Subject: Letter of Clarification No. 1 to Invitation to Bid No. S50-C23560, Concrete Repair Services for Various Departments

Letter of Clarification No. 1
Invitation to Bid No. S50–C23560,
Concrete Repair Services for Various Departments

DRAWING No. 108

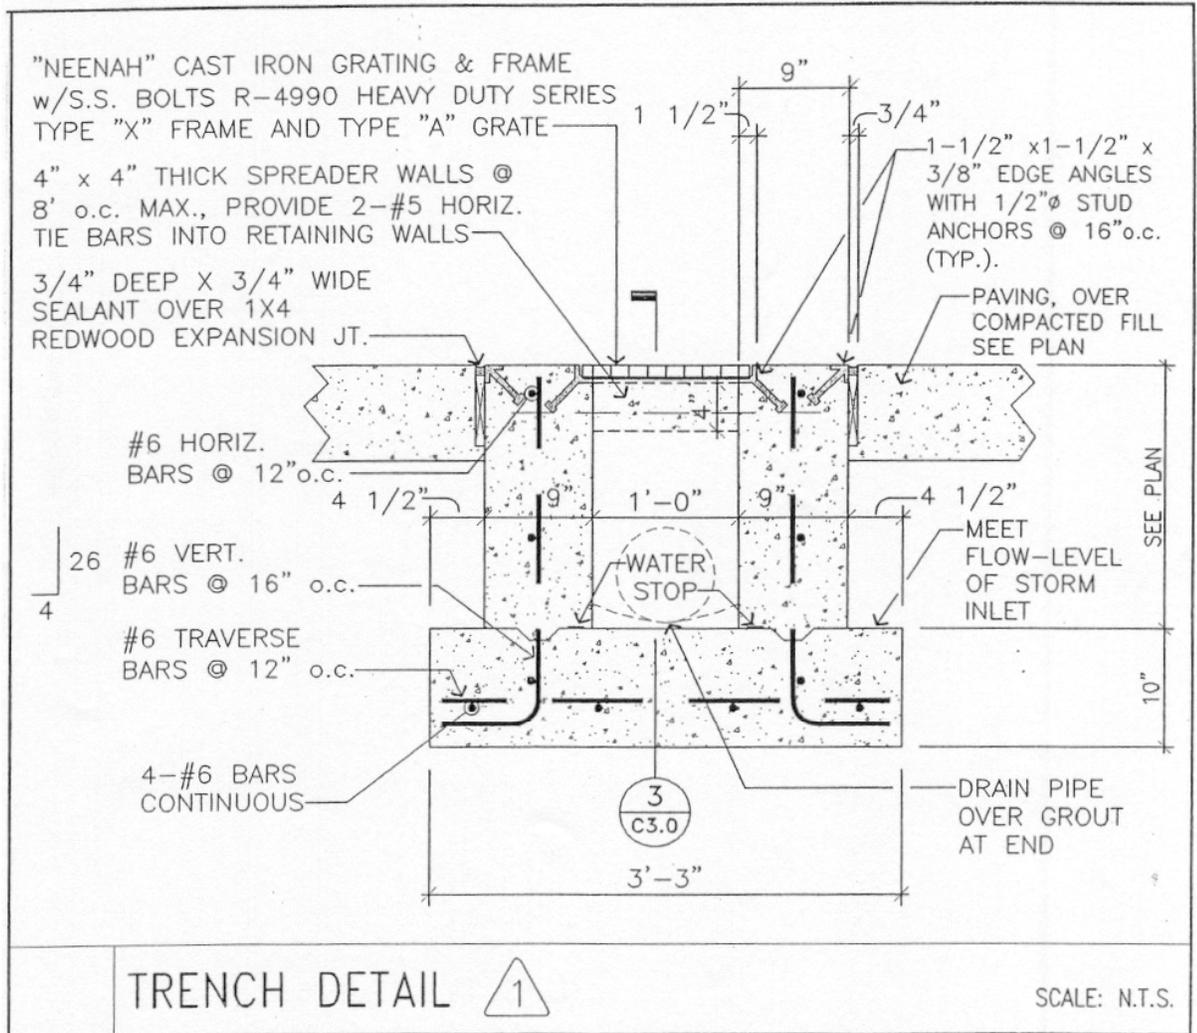
Question No. 11 Line Item 31: Reference drawing is #108, there is no such drawing in the document? Please provide quantity?

Answer: Drawing No. 108 is attached hereto. Also, see the revised electronic bid form for estimated quantities.

DRAWING No. 109

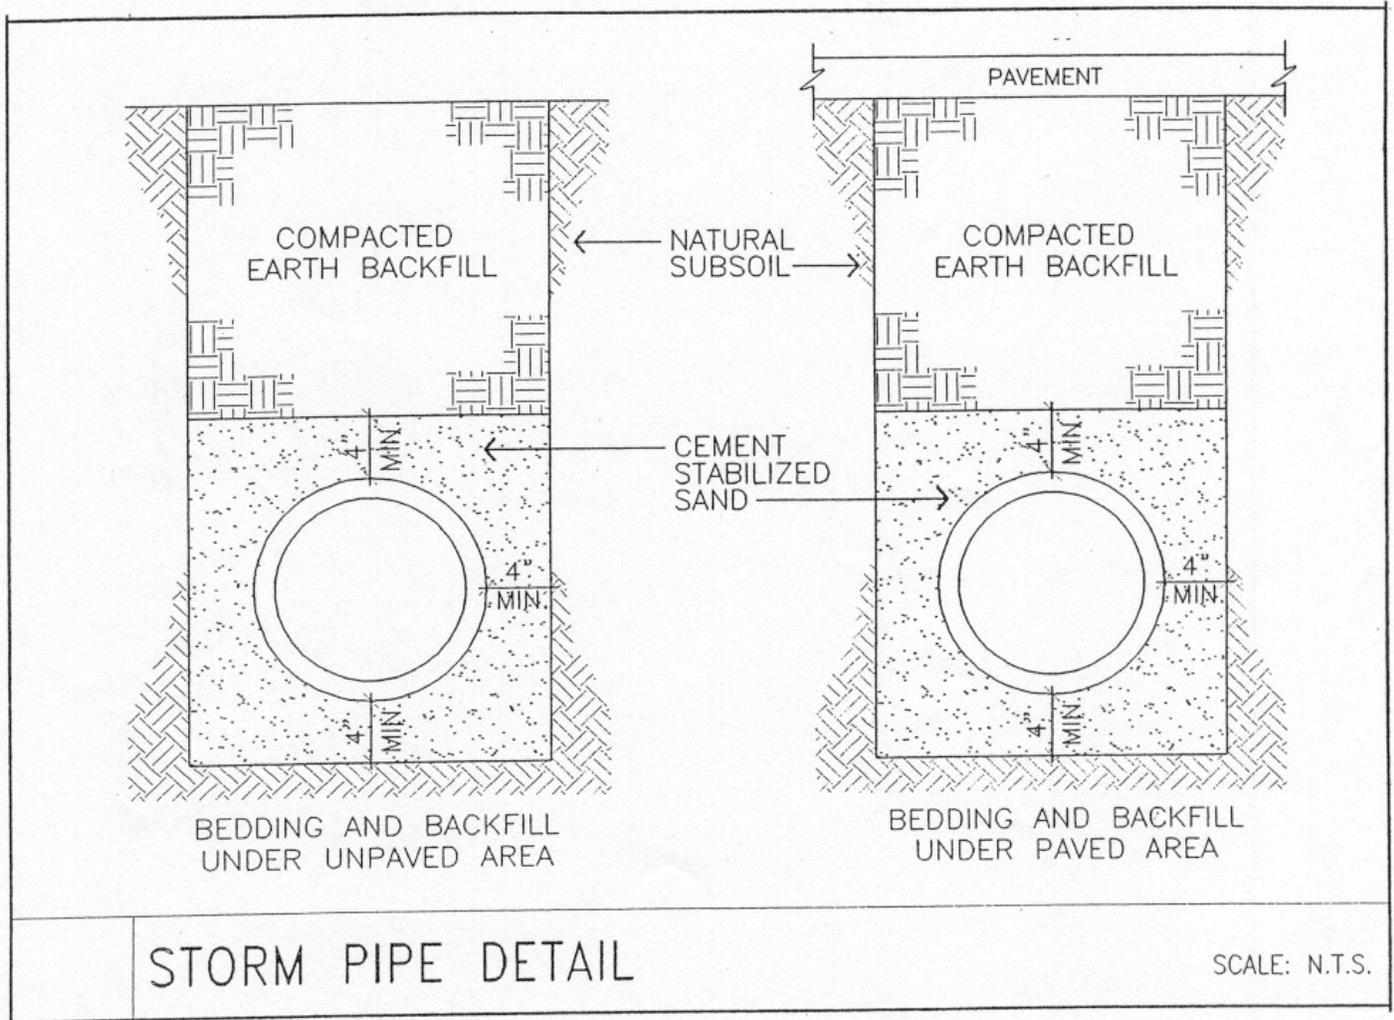
- Question No. 12** Line Item 32 through 46: Reference drawing is #109, there is no such drawing in the document? Please provide quantity?
- Answer:** Drawing No. 109 is attached hereto. Also, see the revised electronic bid form for estimated quantities.
